FORD AXOD/AXODE FORWARD CLUTCH PACK CHANGE LOW SPRAG OUTER RACE CHANGE

CHANGE: Beginning at start of production for 1992 models, all AXODE transaxles were built with a revised low sprag outer race that required revisions on the forward clutches, both lined and steel plates, a new pressure plate and "Wave" plate.

Figure 1

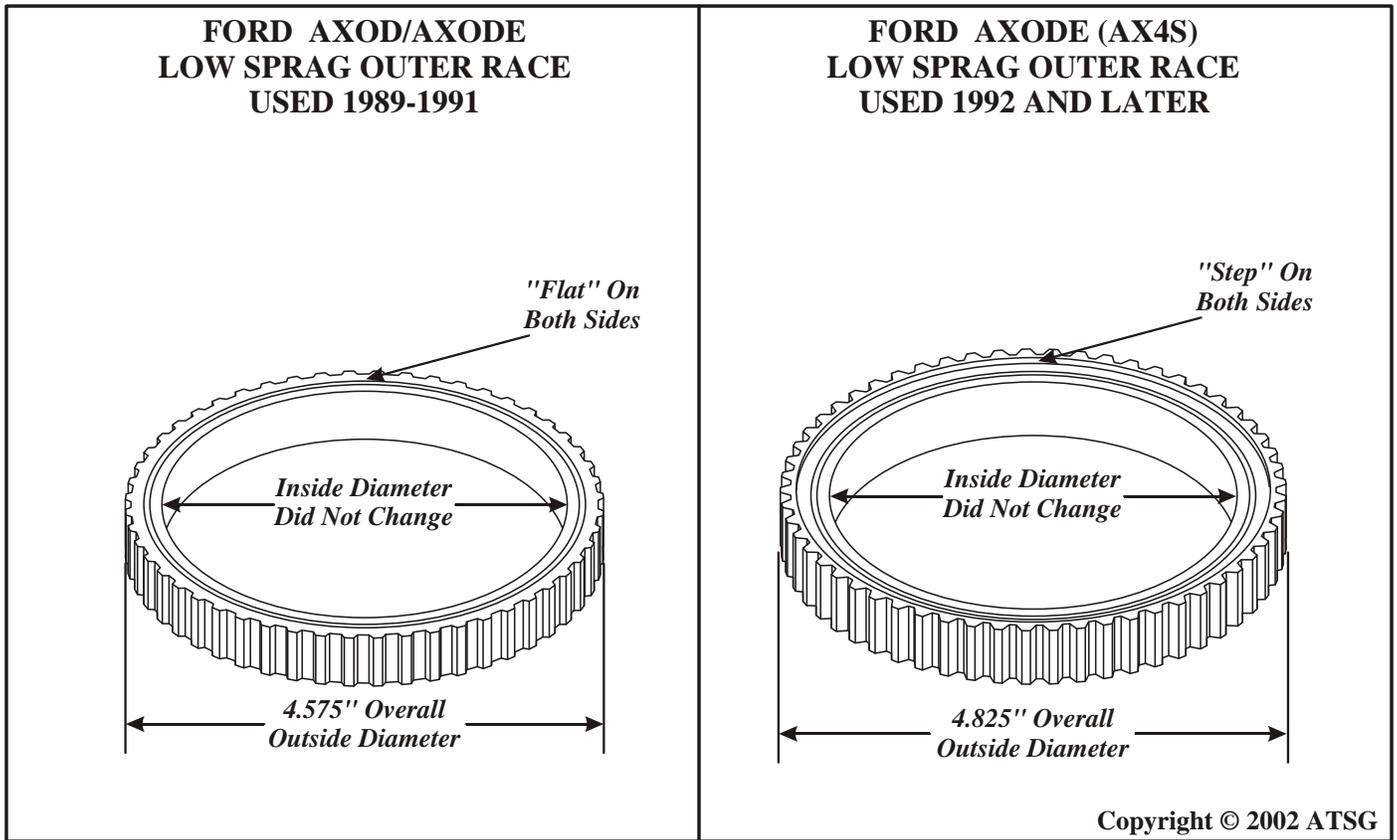
- (1) LOW SPRAG OUTER RACE - The outer diameter of the race was increased from 4.575" to 4.825", and the width of the race was increased from .600" to .725", as shown in Figure 1. *The Inside Diameter of the sprag race Did Not Change.*

Figure 2

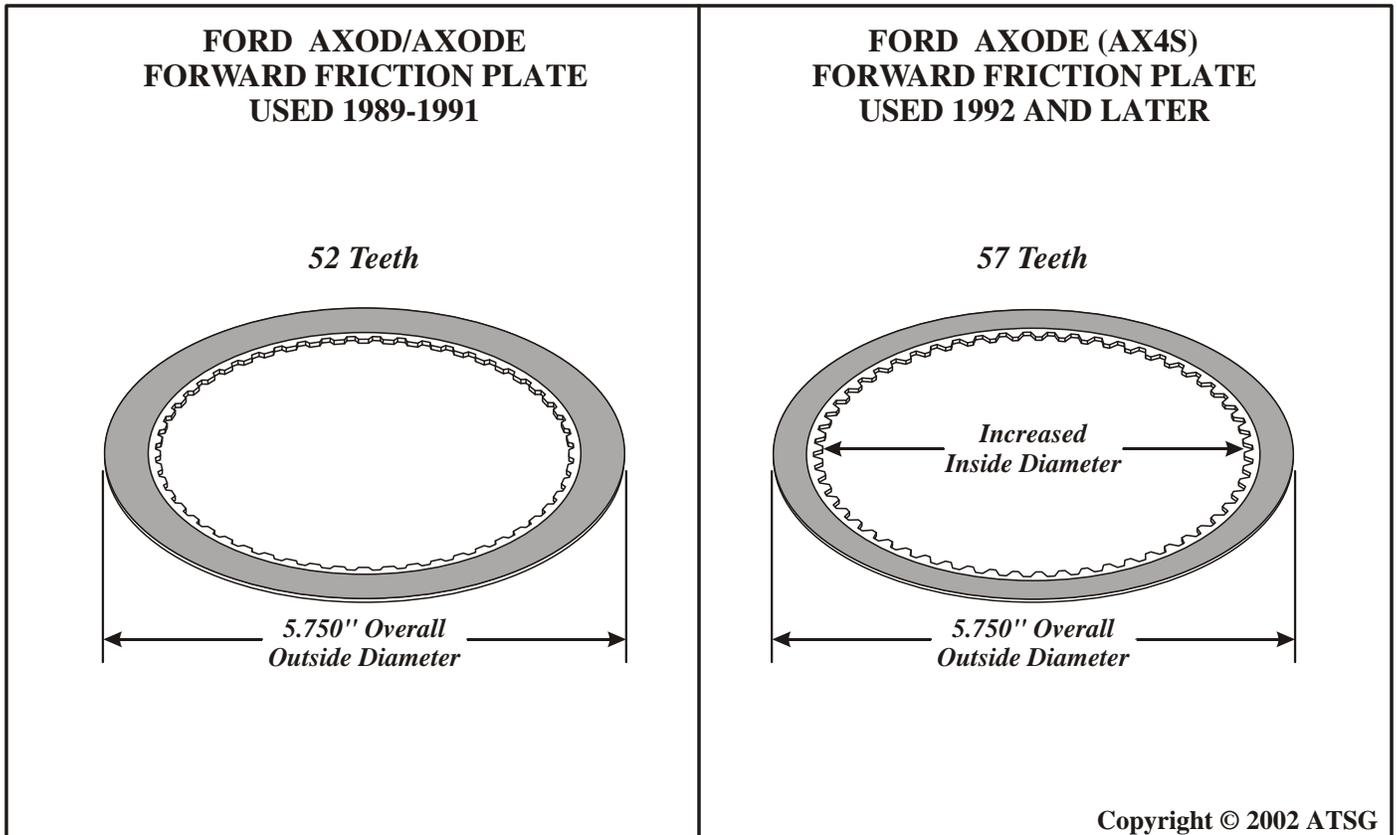
- (2) FORWARD CLUTCH FRICTION PLATES - Have an increased amount of teeth to 57 Teeth from the previous 52 Teeth, to accommodate the increased diameter of the sprag outer race, as shown in Figure 2.

Figure 3

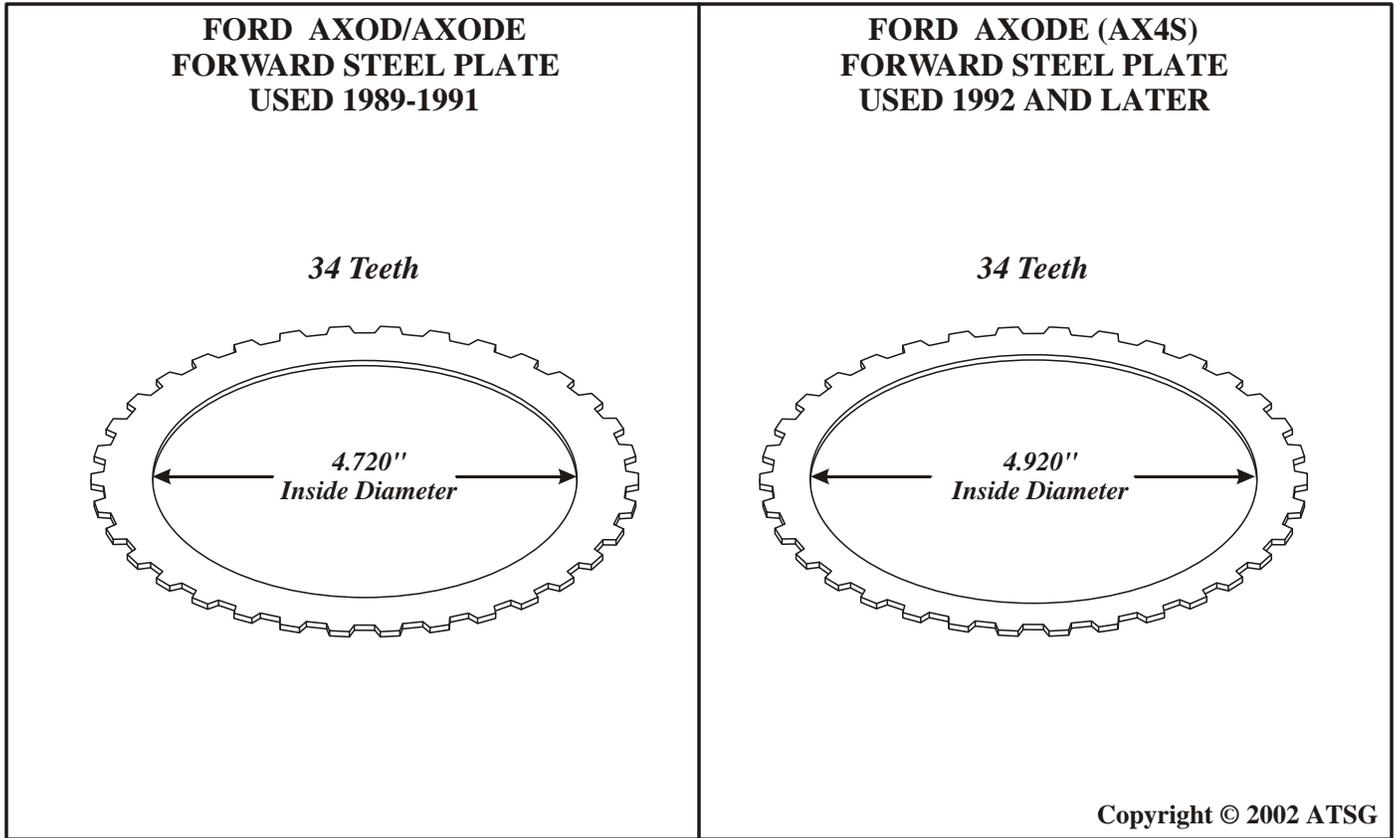
- (3) FORWARD CLUTCH STEEL PLATES - Have an increased inside diameter to 4.920" from the previous 4.720", to accommodate the increased diameter of the sprag outer race, as shown in Figure 3.

Figure 4

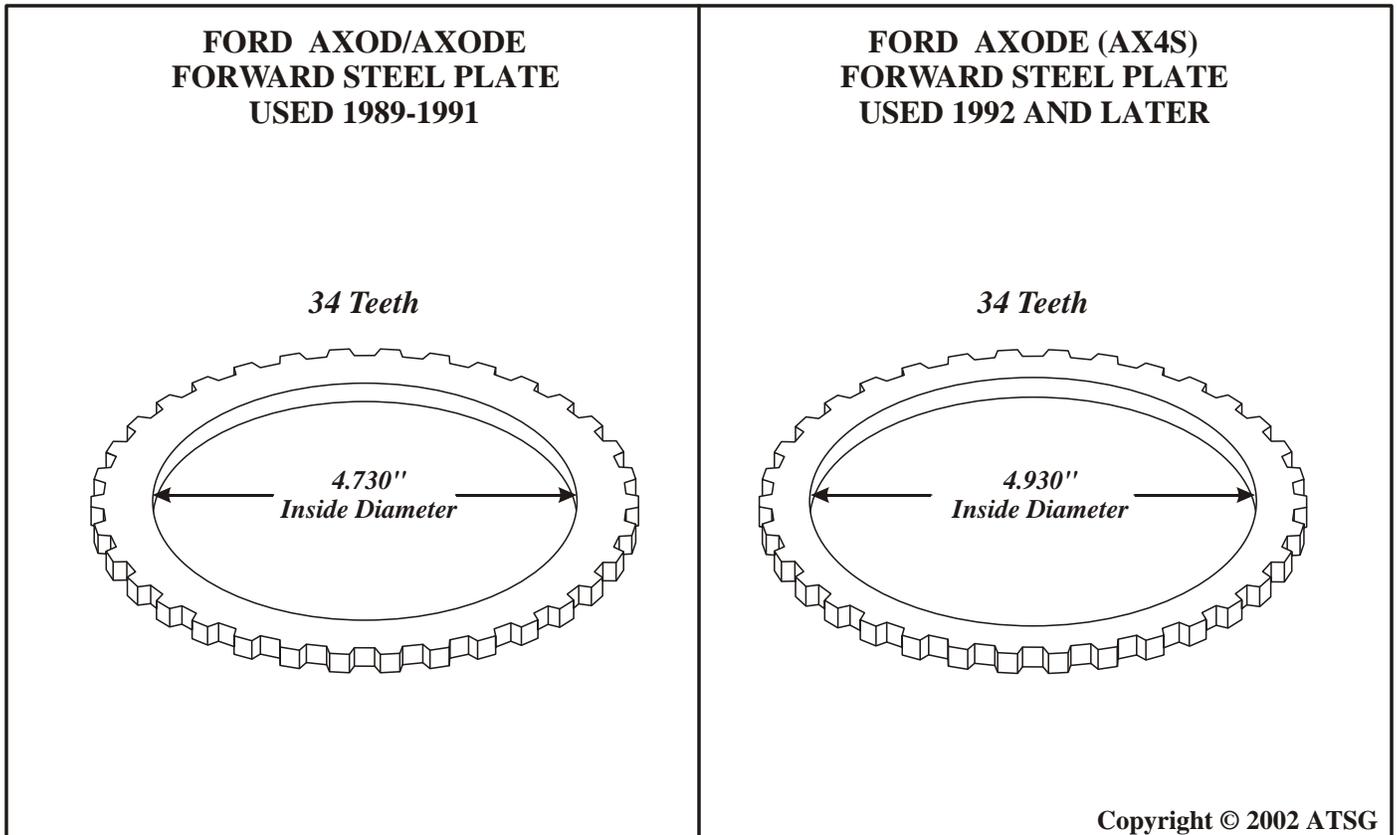
- (4) FORWARD CLUTCH PRESSURE PLATE - Has an increased inside diameter to 4.930" from the previous 4.730", to accommodate the increased diameter of the sprag outer race, as shown in Figure 4.

Figure 5

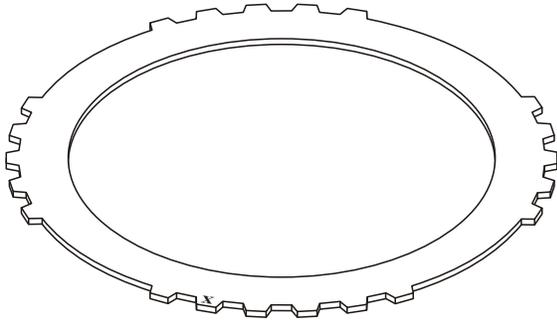
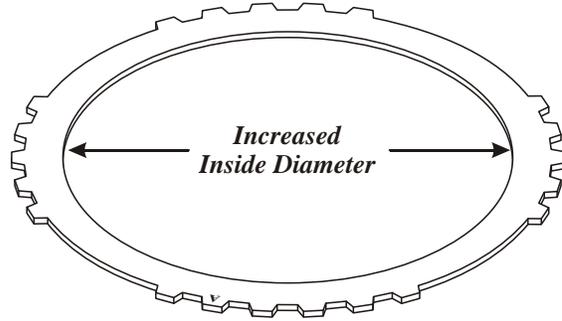
- (5) FORWARD CLUTCH "WAVE" PLATE - Has an increased inside diameter to 4.930" from the previous 4.730", to accommodate the increased diameter of sprag outer race (See Figure 5).

*21 External Teeth
Inside Diameter 4.730"
Material Is .075" Thick
I.D. Stamped "X" On 1 Tooth
Part Number F0DZ-7E085-A*

*21 External Teeth
Inside Diameter 4.930"
Material Is .083" Thick
I.D. Stamped "A" On 1 Tooth
Part Number F2DZ-7E085-A*
